DESIGN MEMORANDUM NO. 14.1

RECREATION FACILITIES and PUBLIC USE AREAS

Little Goose Reservoir

SUBJECT: Little Goose Project, Design Memorandum No. 14.1, Recreation
Facilities and Public Use Areas, Little Goose Reservoir

C 72Jun16 Revised and redrawn.
 B 71Mar31 Revised March 1971.
 A 02Jul70 Replaces original Plate 5.

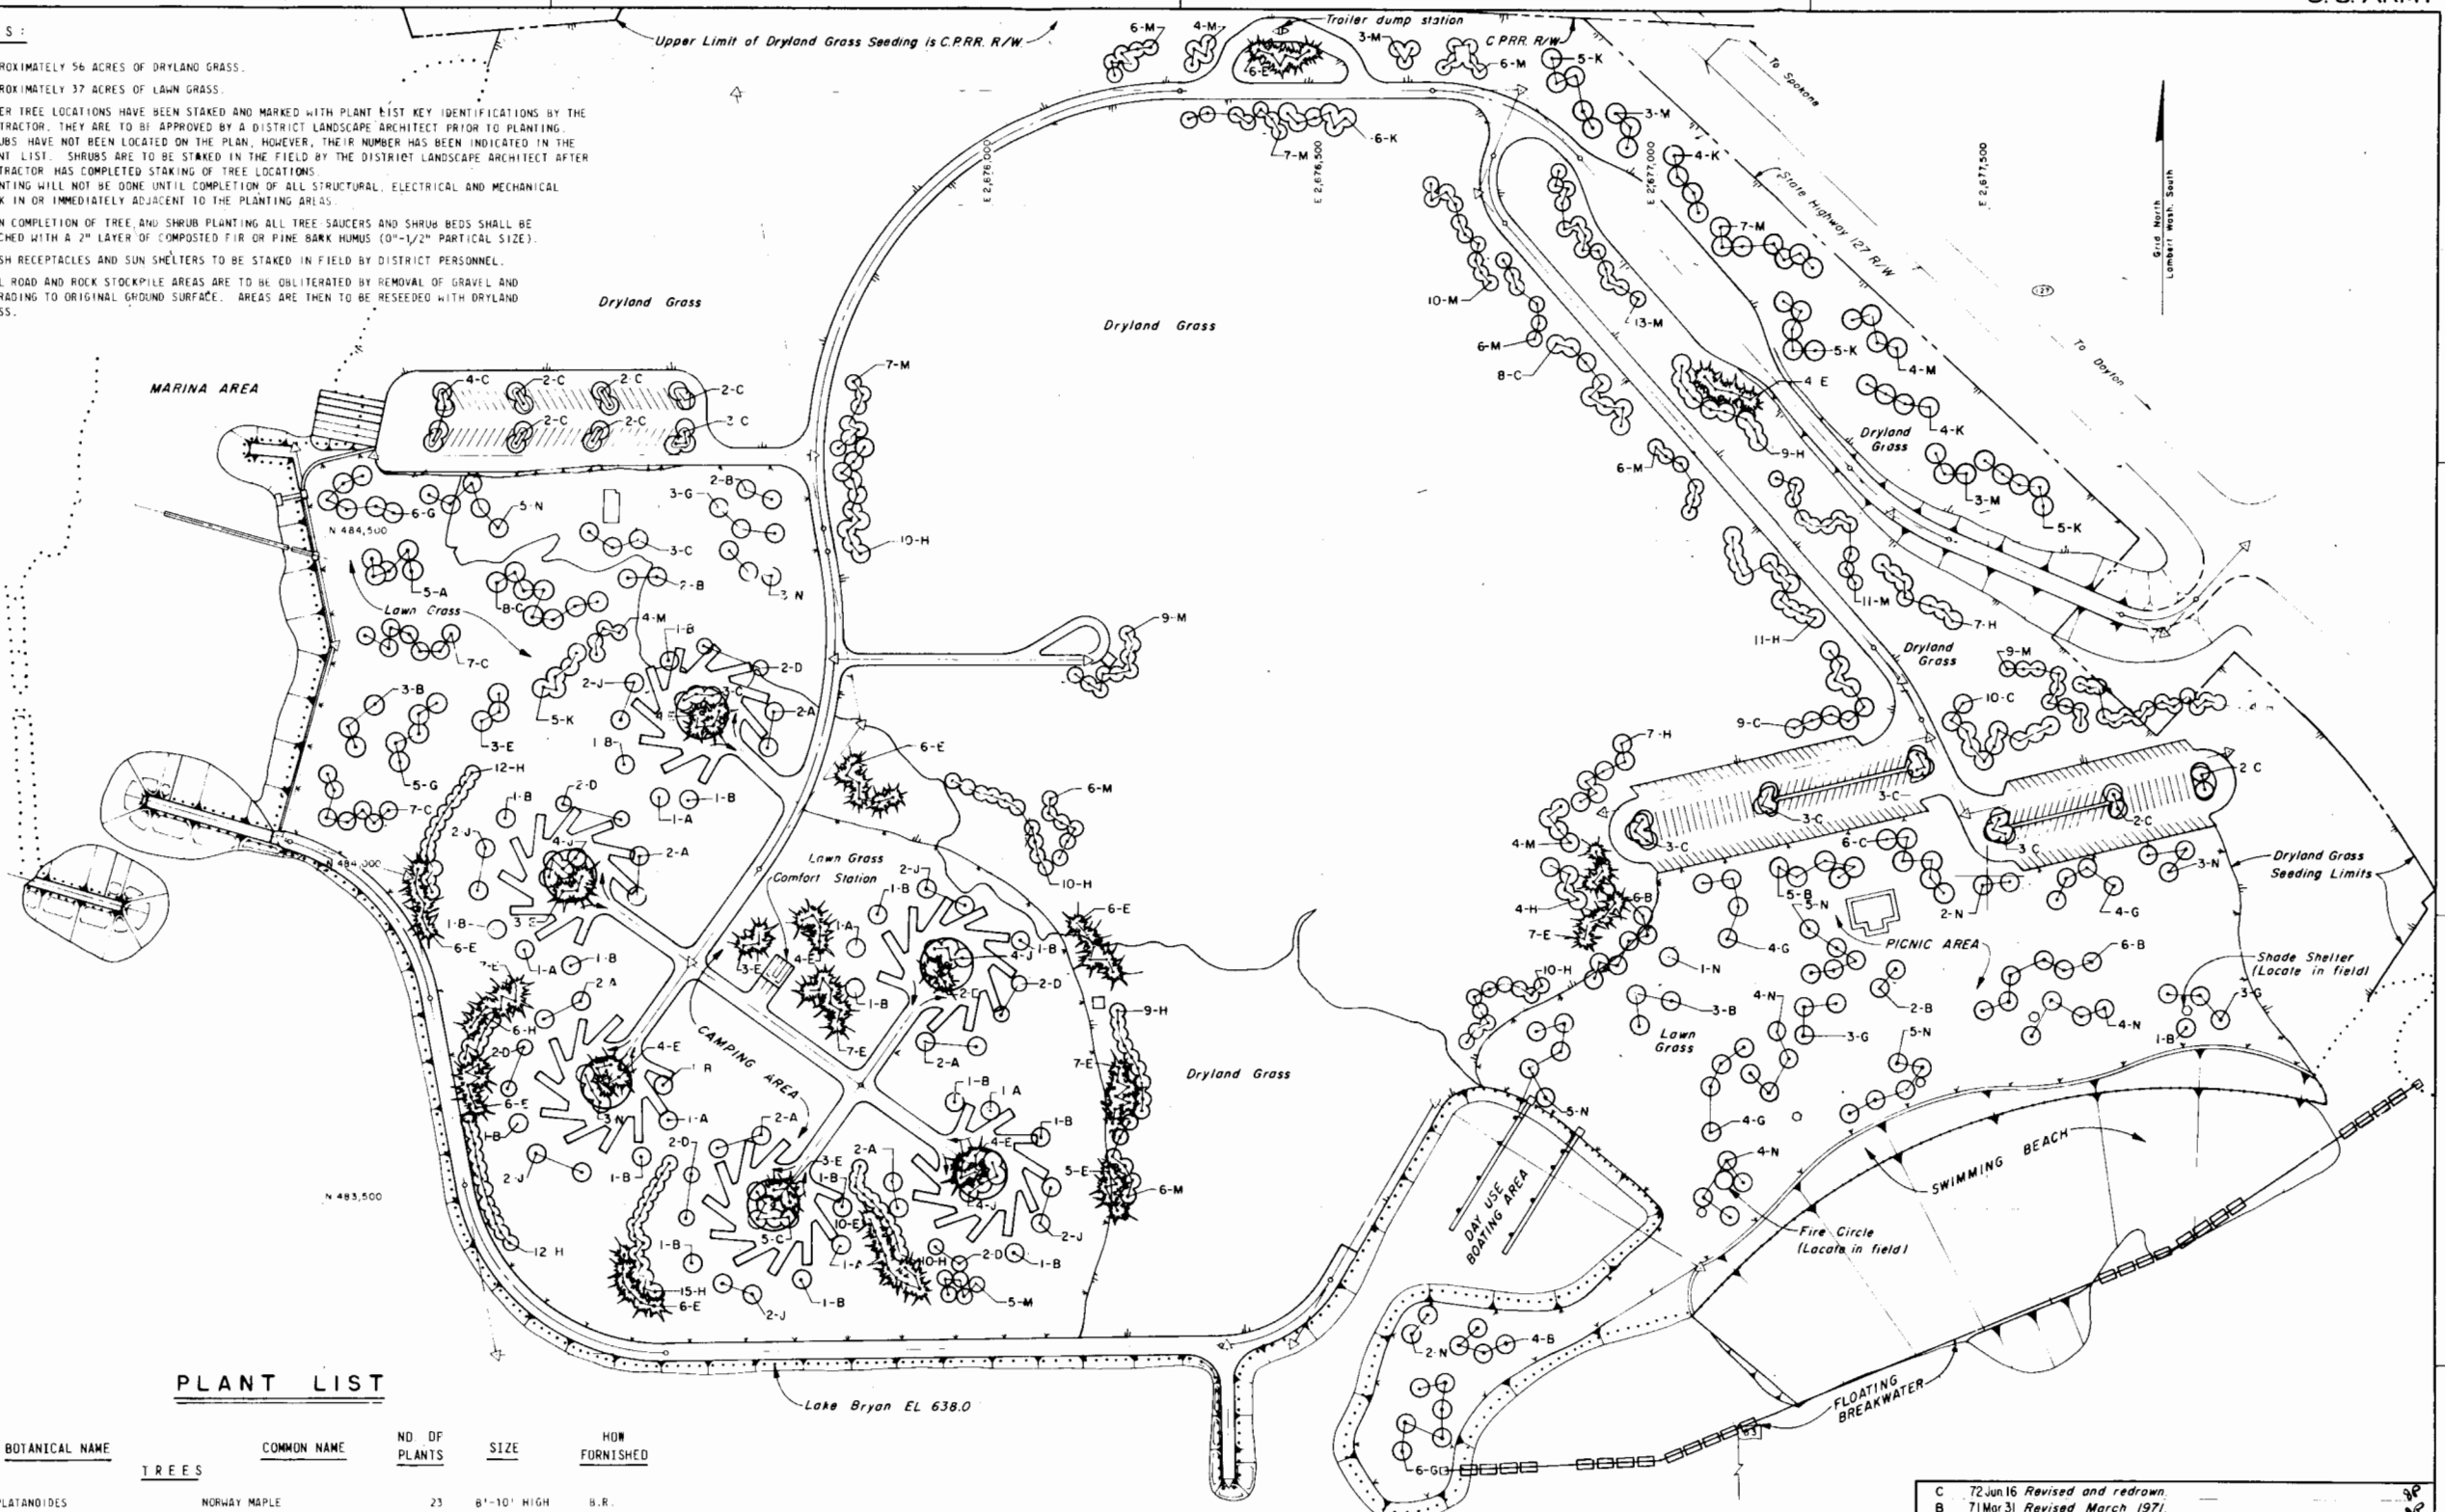
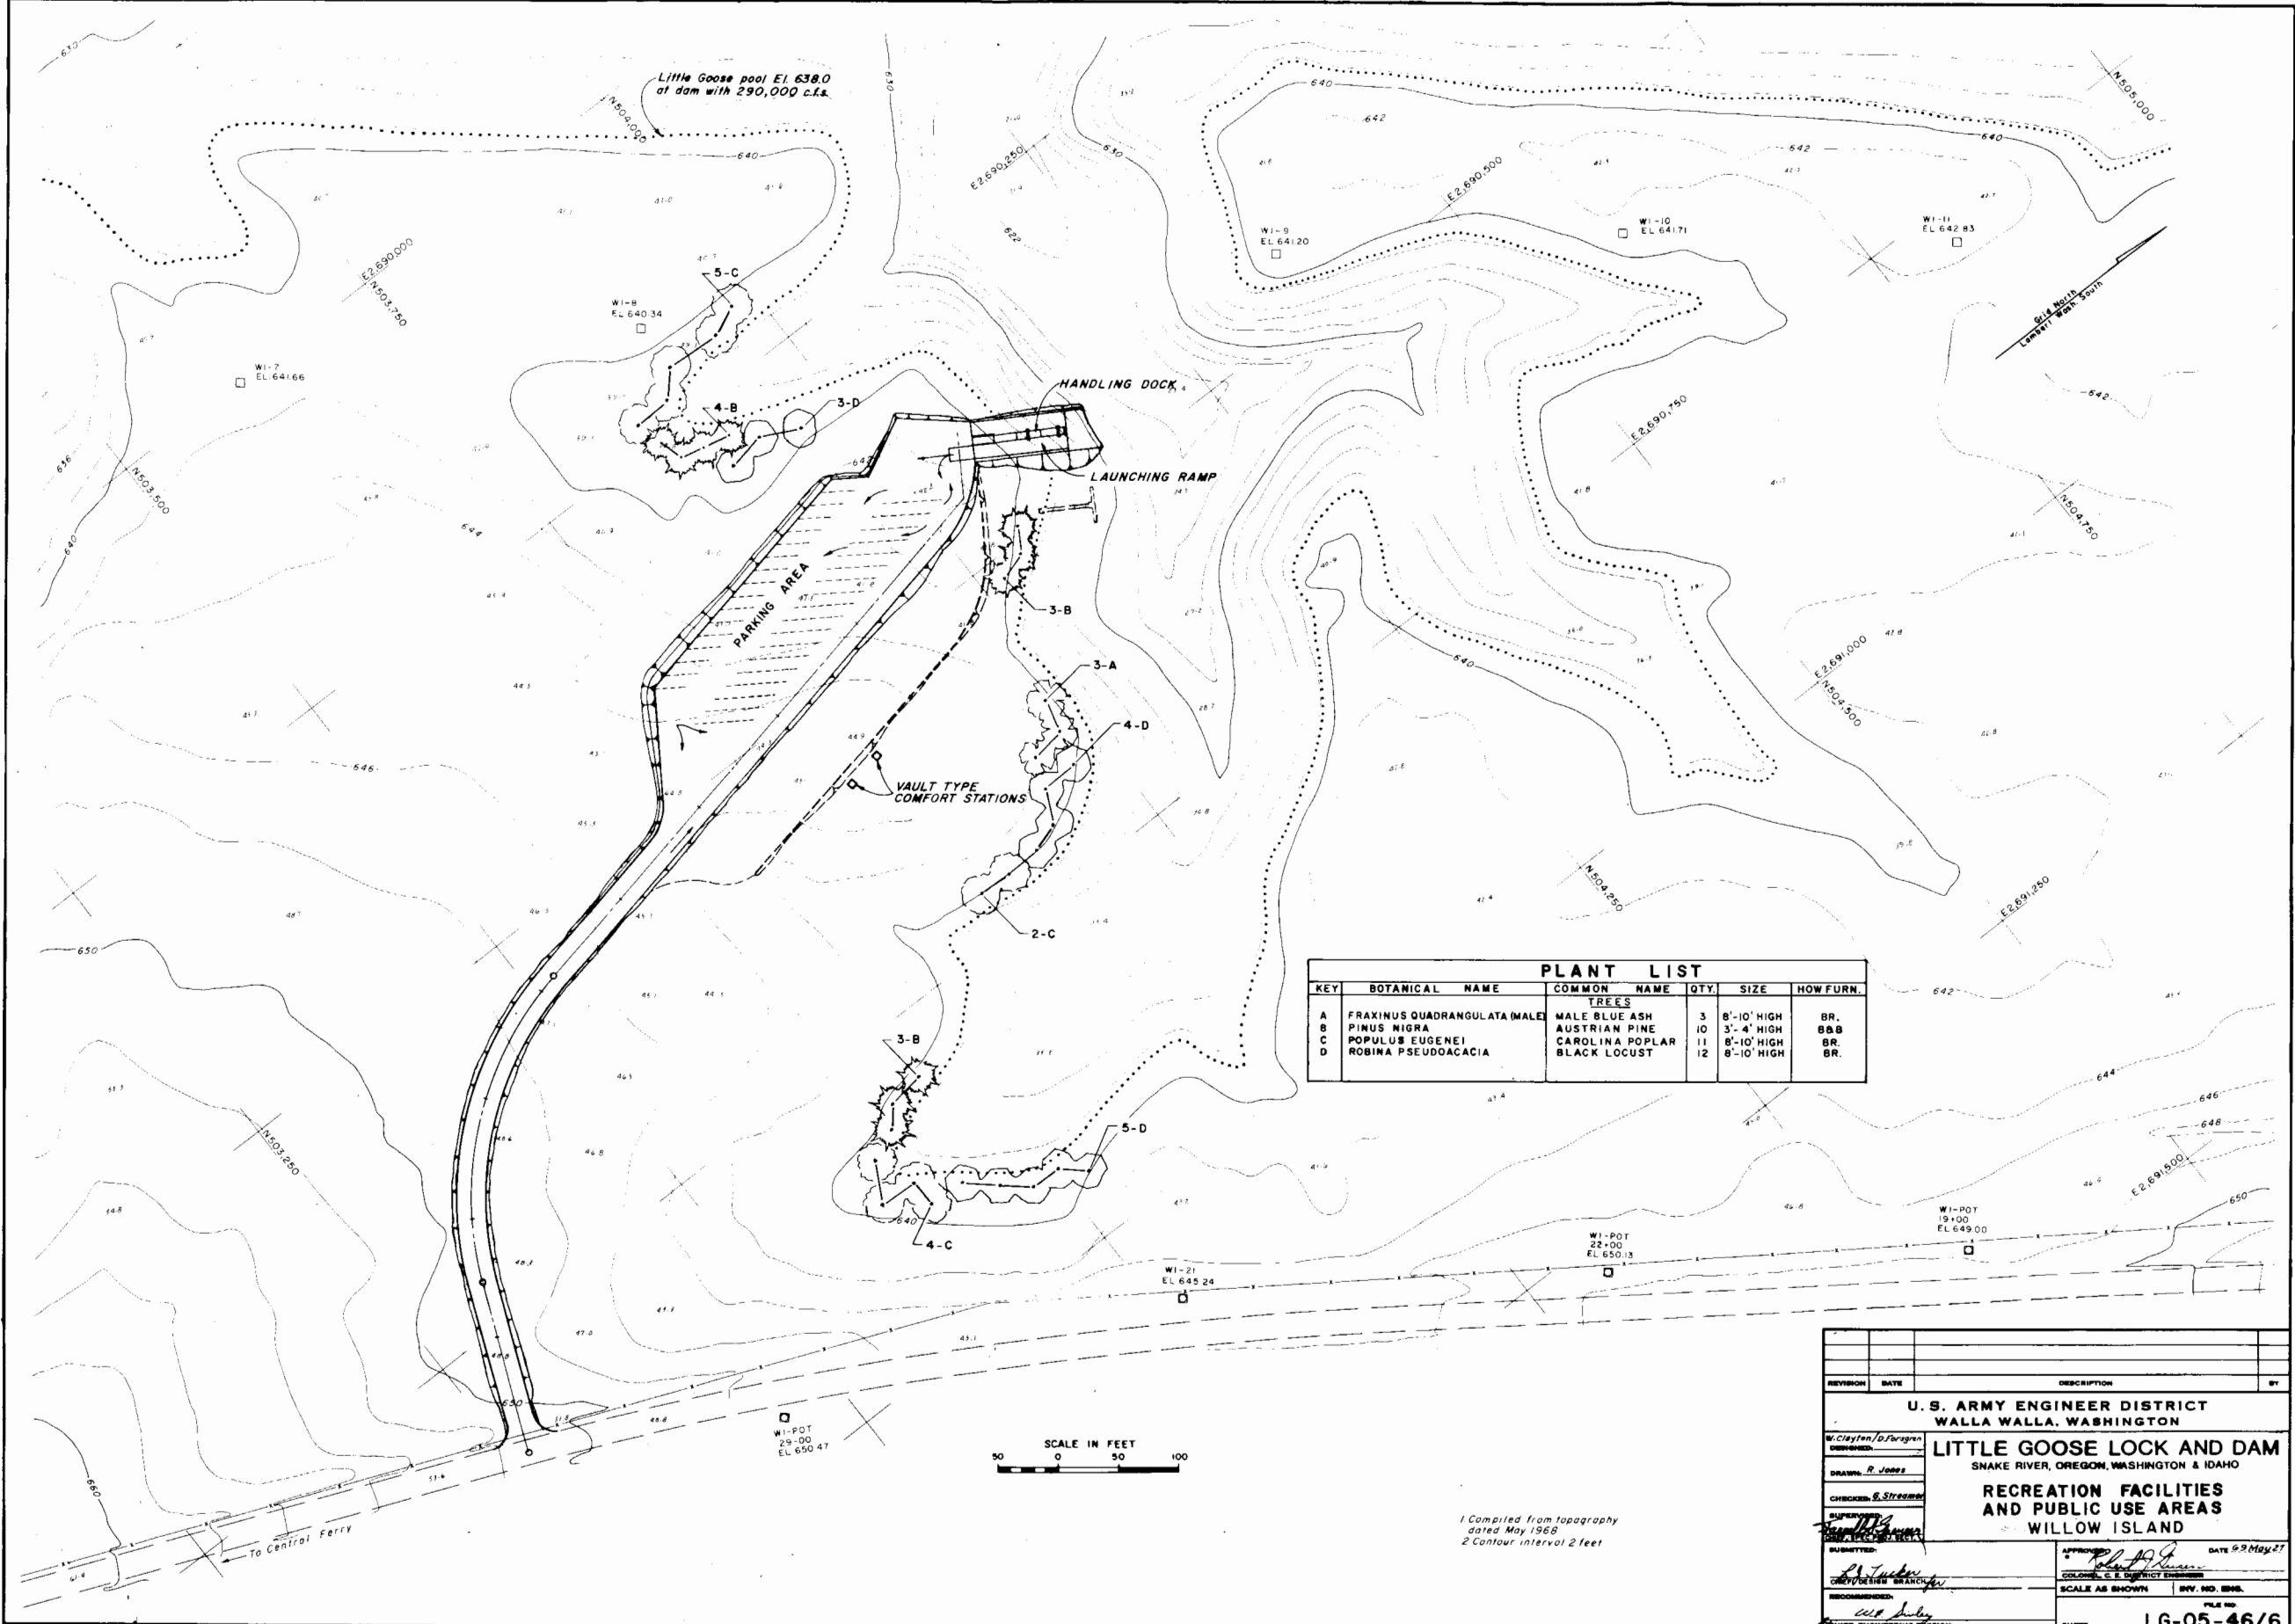
(1) Plate 3 dated 27 May 1969 indicated 120 units in 2 future camp areas. No future units are shown on the revised plan. If such units are planned for the future, their tentative location should be shown on the revised plates 3 and 5.

(1) Plates 3 and 5 have been revised to show location of the future camp sites. Revised copies are inclosed for insertion in your copies of the design memorandum.

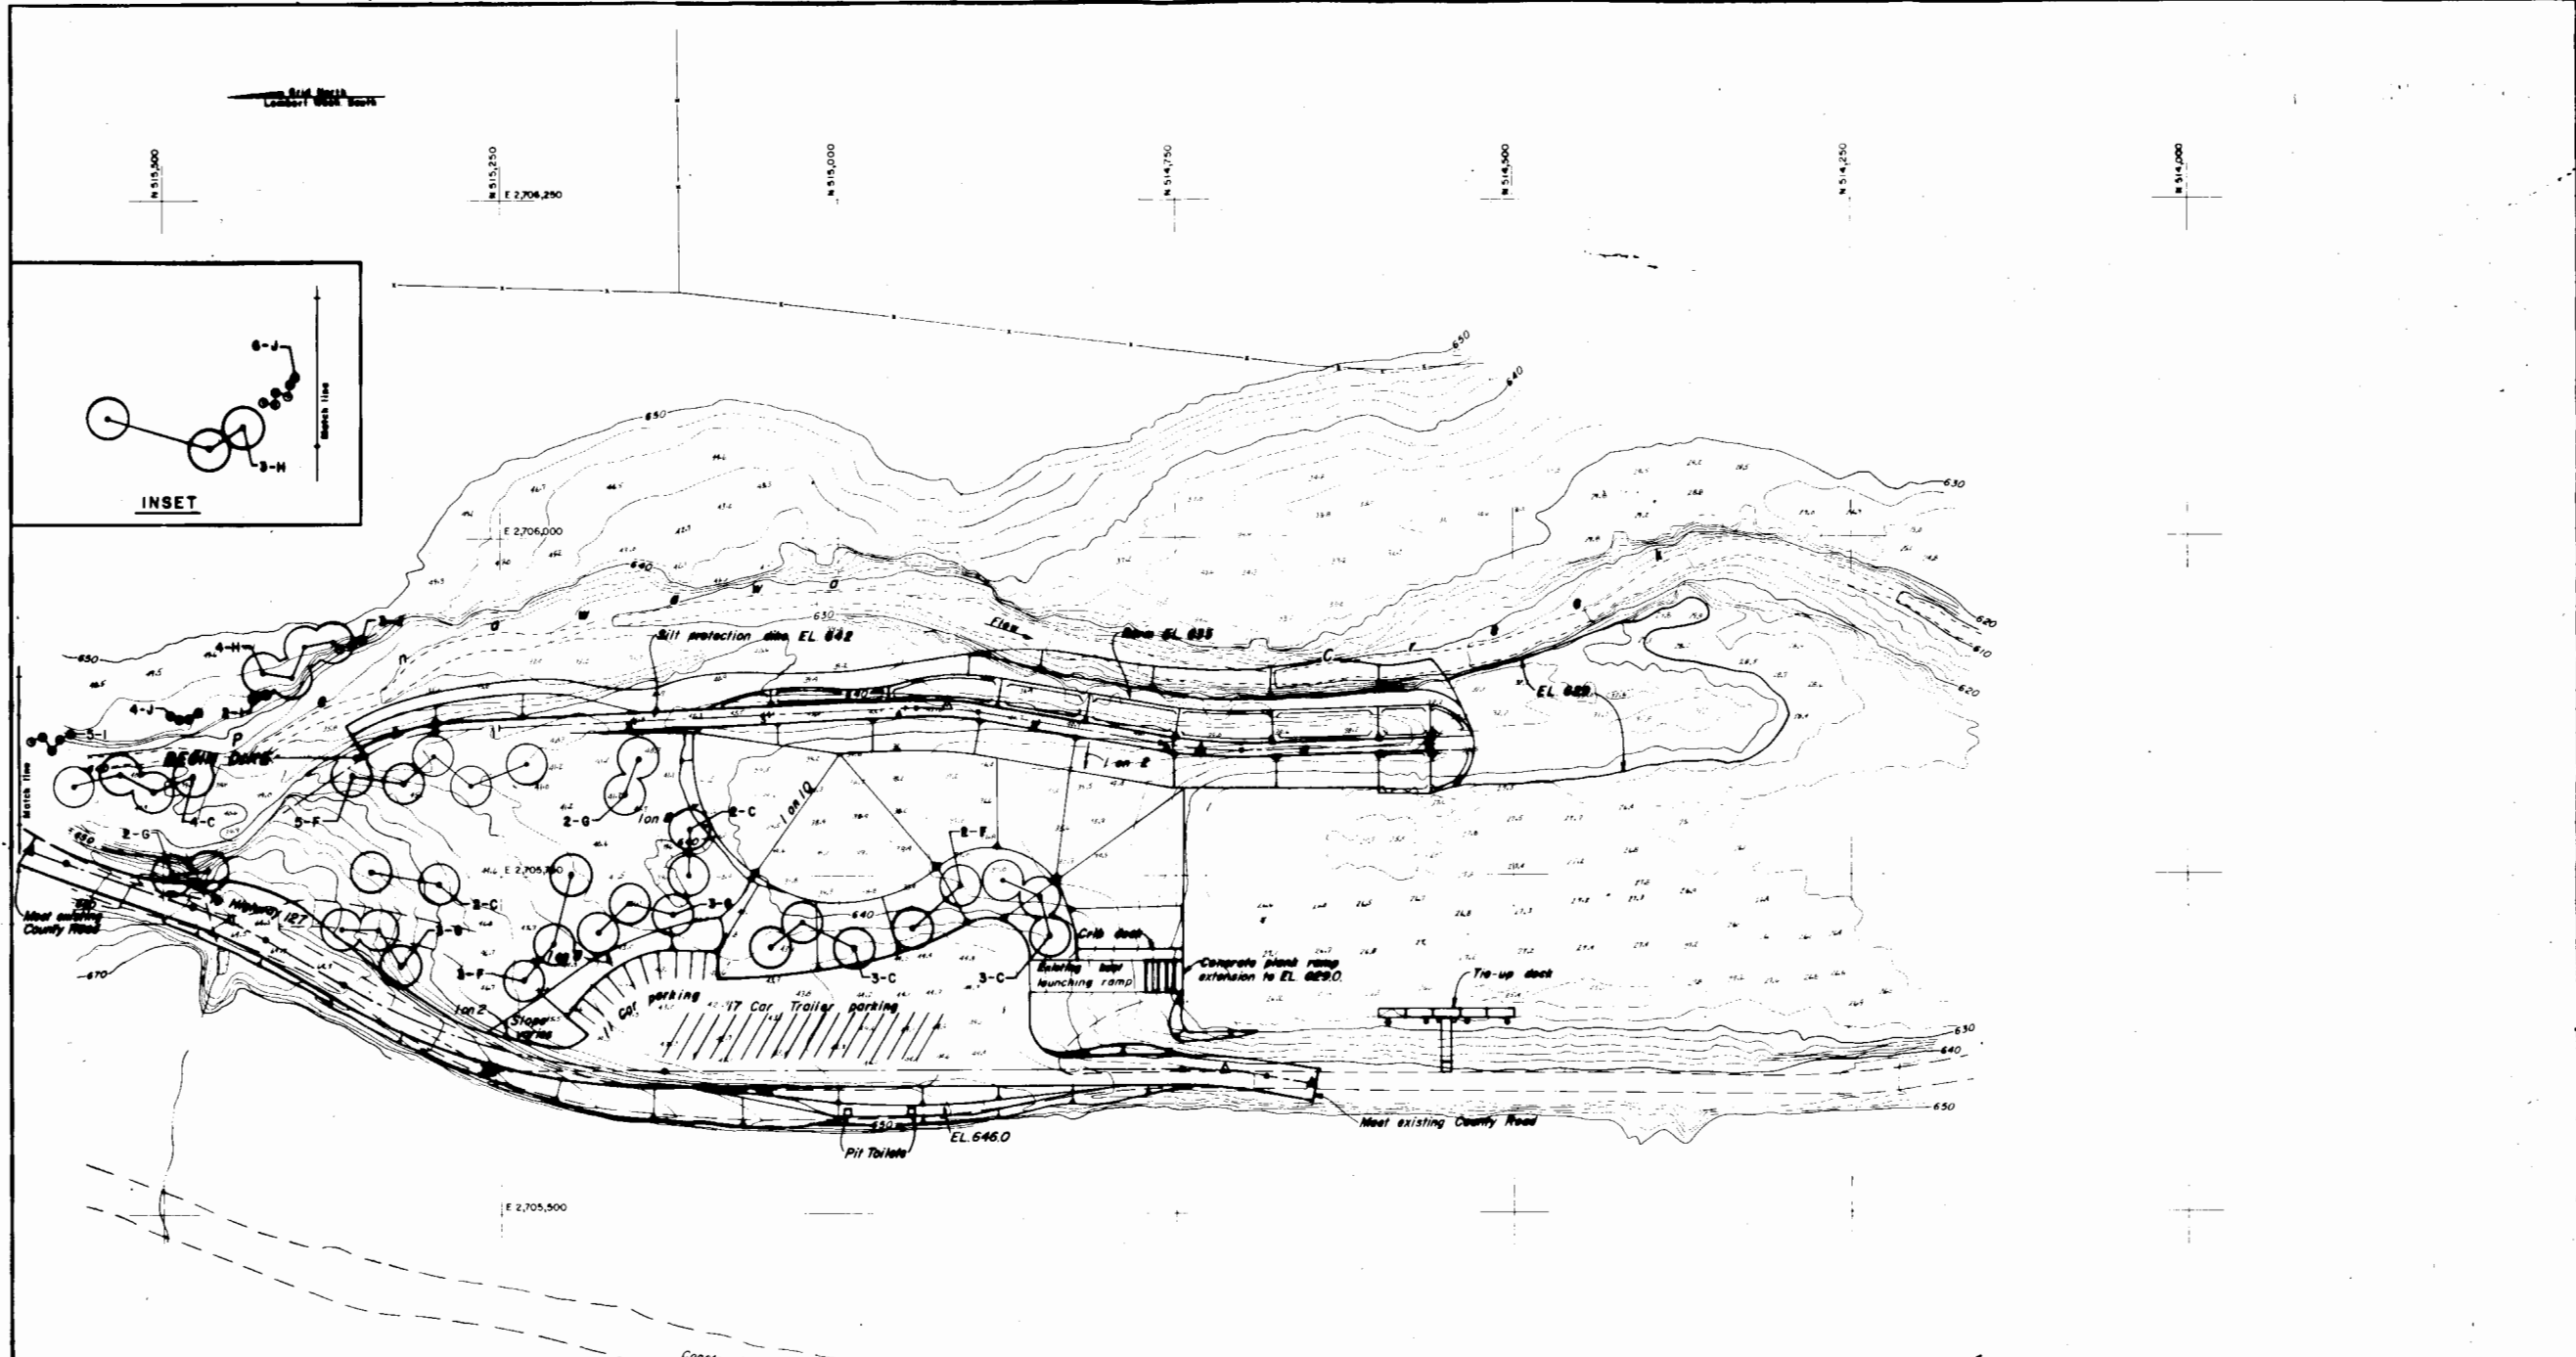
c. Plate 7 and revised paragraph 3.05, Penawawa Site: Provide justification for the small tie-up dock not previously included in prior approved plans.

(4) Redesign of the Penawawa Site was necessitated by filling of the reservoir prior to construction. The new layout is shown on revised Plate 7. Prior to impoundment, the Port of Whitman County had considerable grading work accomplished by hired labor forces. The work included excavation of the boat basin to below the 629 elevation, construction of a concrete launching ramp, partial construction of the silt dike, grading of the parking area, and raising of the old road to above reservoir level. This work was accomplished so some facilities would be available to the local citizens until the Corps construction was accomplished. As compensation for the work performed by the Port of Whitman, the Corps agreed to construct some tieup docks at this site. The value of the tieup docks to be constructed by the Corps is \$13,200. The cost to construct underwater is \$40,000 and was accomplished by the Port of Whitman. The revised cost estimate shown on Table 6 reflects redesign of the site and savings for work accomplished by the Port.
